11 December 2019

5809\_312\_DPIE\_ES Submission.docx

**RE: Hanson Sancrox Quarry SSD Application No. 7293**

Site Plan Indicating Location of Investigations

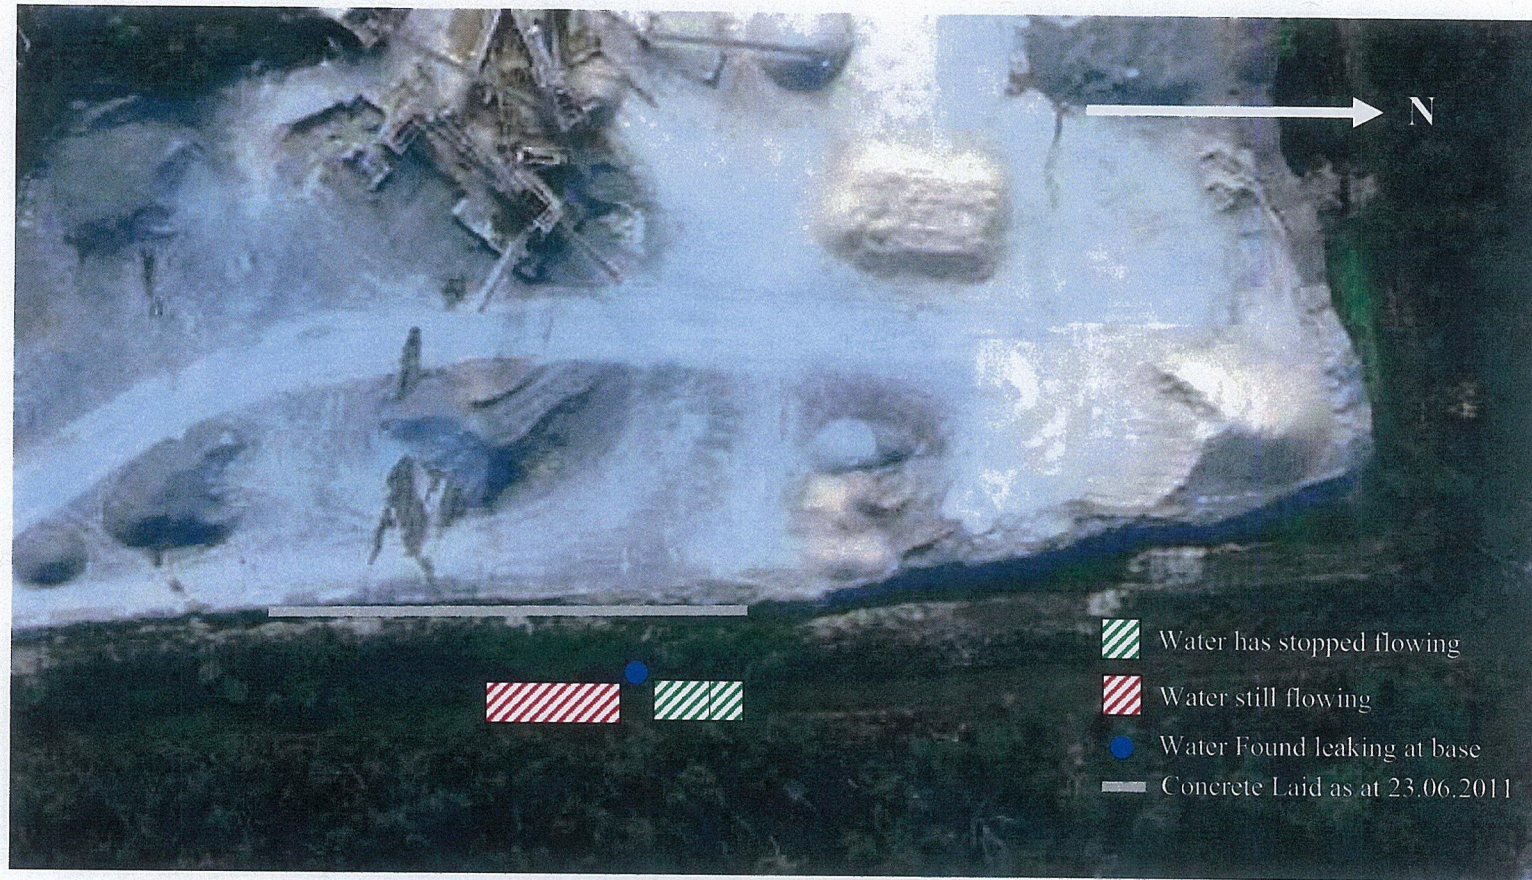
Since laying concrete in the section of drain that appeared to be leaking (seen in Photos 1 & 2), we can see by the area on the Site Plan shaded in green, and by Photo 3, we have stopped the water leaking in this area.

However, slightly further to the South, the area is still very wet, which is shaded red on the Site Plan and seen in Photo 5.

However, on further investigation by myself, after cutting back some of the overgrowth in the 'wet area,' and digging into the ground, water can be seen running out of the ground. The location of this can be seen as indicated by the blue circle on the Site Plan and in Photos 4 & 5. The location of the leak is approximately 1.5m lower than the base of the drain.

Where to now? We have approximately 5 days pumping to empty the sump in the pit (pending further rain). Once this is complete, we will be able to empty the drain and complete the concrete works in this area. When we are confident that no water is able to escape along this section, further investigation will be carried if the leak found today continues.

DRAWING TITLE: QUARRY SECTION LOCATIONS - EXPRESSWAY SPARES

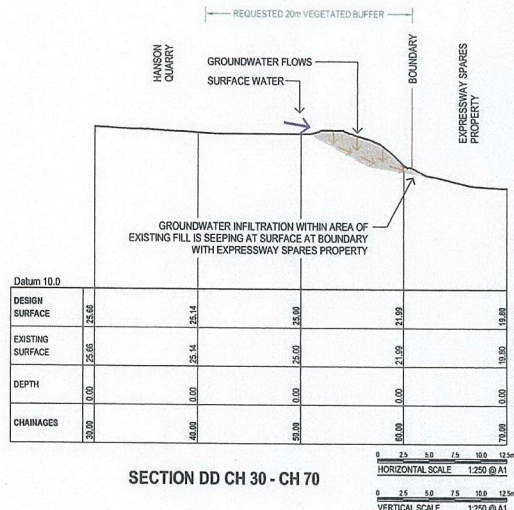
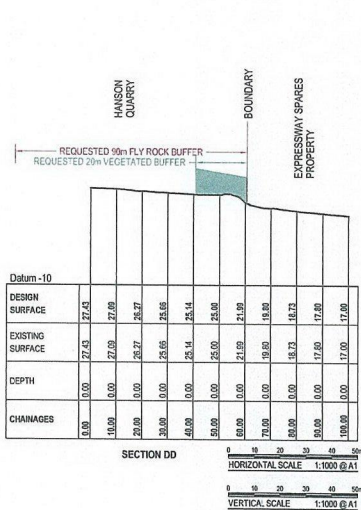
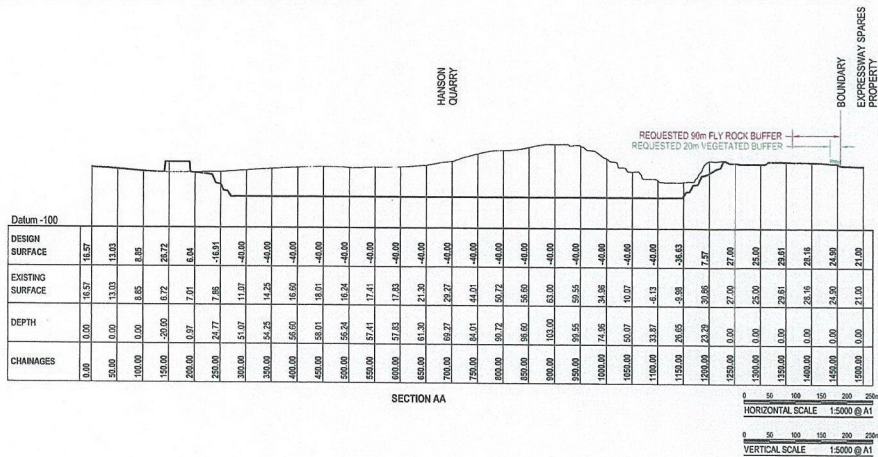
**Attachment C** contains cross-sections prepared by King & Campbell. Section DD shows the origins of this stormwater drainage issue from within the gravel and loosely filled established sales floor. The ongoing seepage of water from the sales floor has occurred over the lifetime of the quarry.

**Connectivity Value - Post Development Site**  
**Connecting Links**  
**(Current linkage widths)**

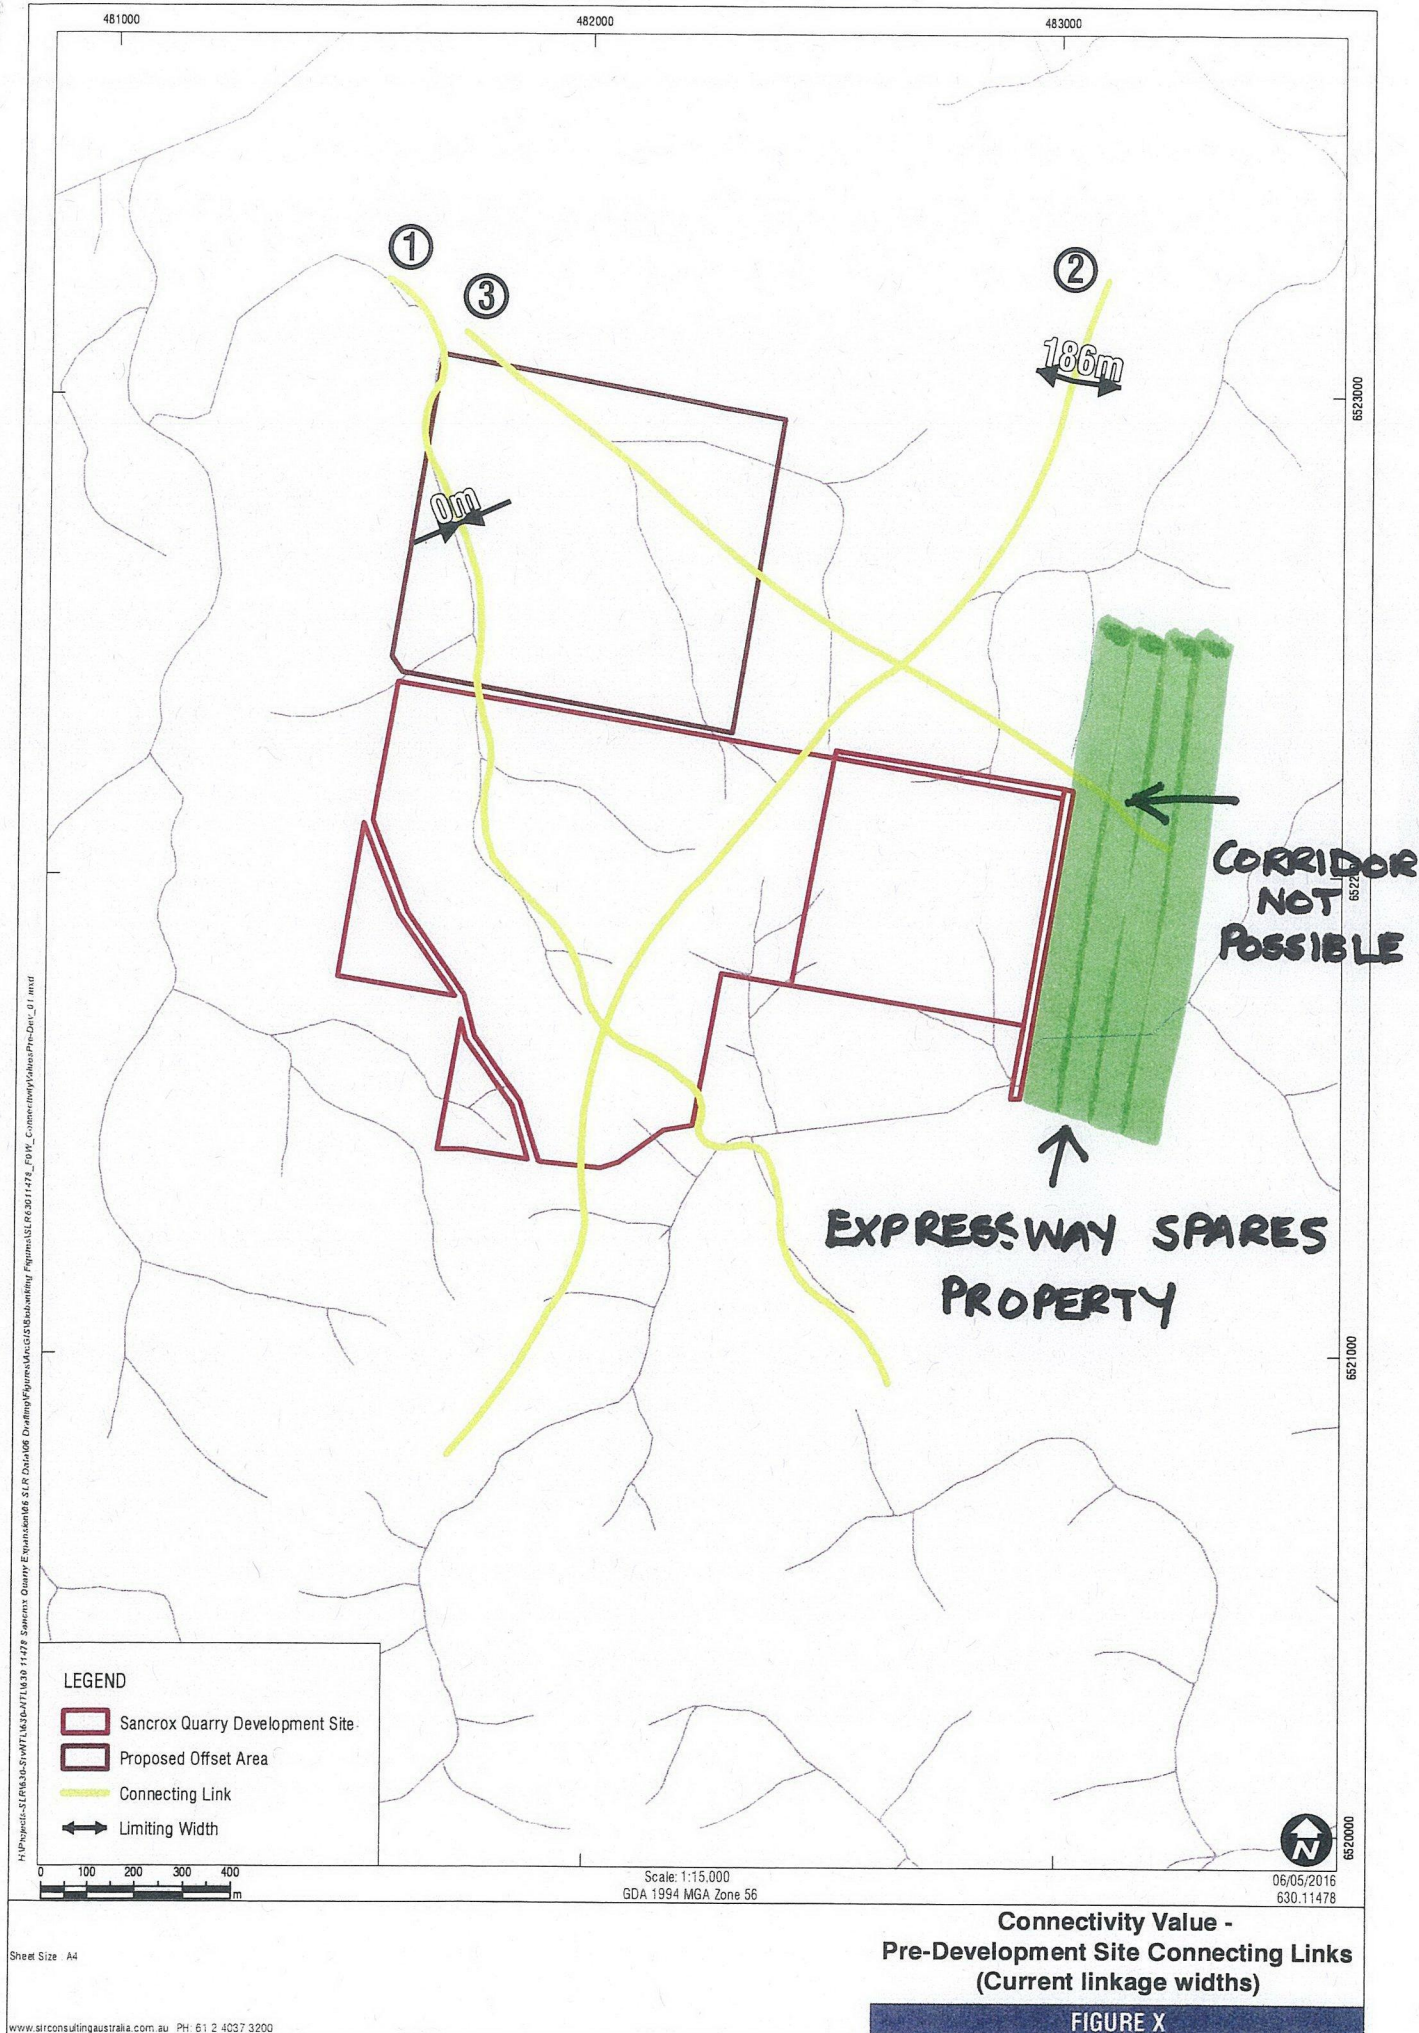
Attachment E includes a copy of the SLR Consultant suggestion regarding a "Post Development Site Connecting Link" of 85.3 metres on Expressway Spares property.

This suggestion fails to understand that the property is in the process of being development for an industrial subdivision and given that lack of understanding of the surrounding properties we query what else is being missed within the SLR work. Mitigation for loss cannot be made up on neighbouring properties, especially one that is zoned general industrial.

DRAWING TITLE: QUARRY SECTION LOCATIONS - EXPRESSWAY SPARES  
PROJECT: SANCRON ENTERPRISE ZONE - QUARRY INVESTIGATION  
LOT 353 DP 754036, LOT 2 DP 574036, LOT 1 DP 555055, ORLEANS AVENUE, SANCRON  
CLIENT: EXPRESSWAY SPARES PTY LTD

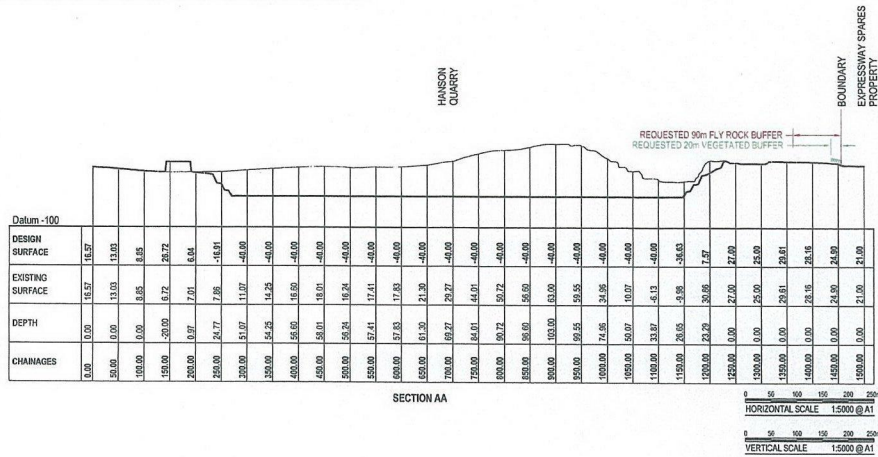
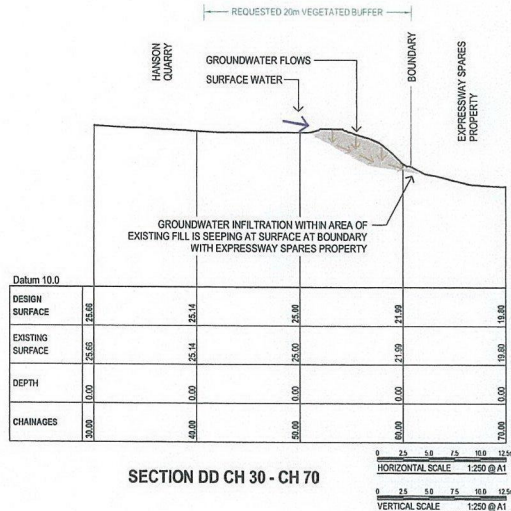
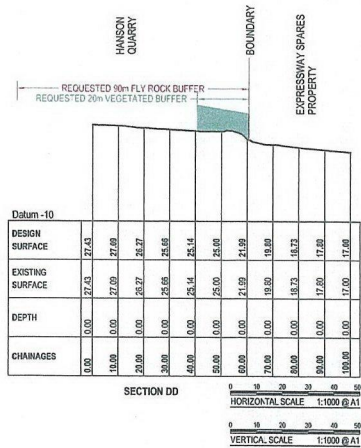
Given the scale of the proposed development and the nature of the crushing and processing equipment, it is submitted that a bund wall be placed along the Eastern boundary adjacent to Expressway Spares property in order to deal with noise issues.

Whilst the Expressway Spares properties in the area are zoned industrial and noise is less of an issue for an industrial property than for a residential property, we submit that a bund along the Eastern boundary could also be utilised as a visual screen.

**Attachment F** contains a plan and cross section of the eastern quarry boundary and shows the Expressway Spares' suggested bund wall location and extent.
